RFP 1169193
 Construction Services for Noyes Library for Young Children - Rehabilitation and Renovation
 Solicitation Amendment 2
 Revised C-3

PROJECT
 NOYES CHILDRENS LIBRARY
 10237 CARROLL PLACE
 KENSINGTON, MD 20895

ISSUED
 ISSUED FOR BID
 01 MAY 2024
 RFP# 1169193

C-3
 GRADING & UTILITY PLAN

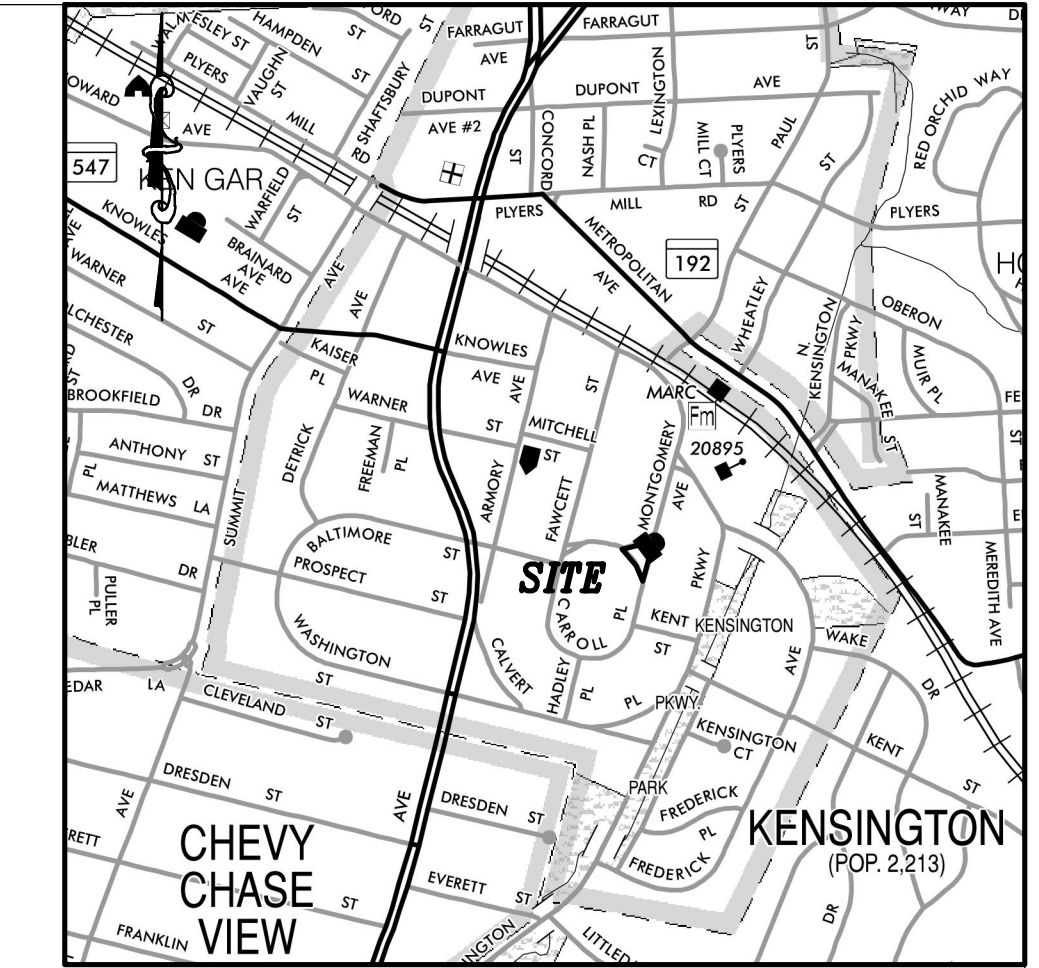
Item No. 17 **QUESTION:** Please provide missing details for full depth asphalt repairs at Carroll Place and Montgomery Avenue utility work.

RESPONSE: Pavement patch detail has been added to sheet C-3A with callouts on C-3 and C-3B.
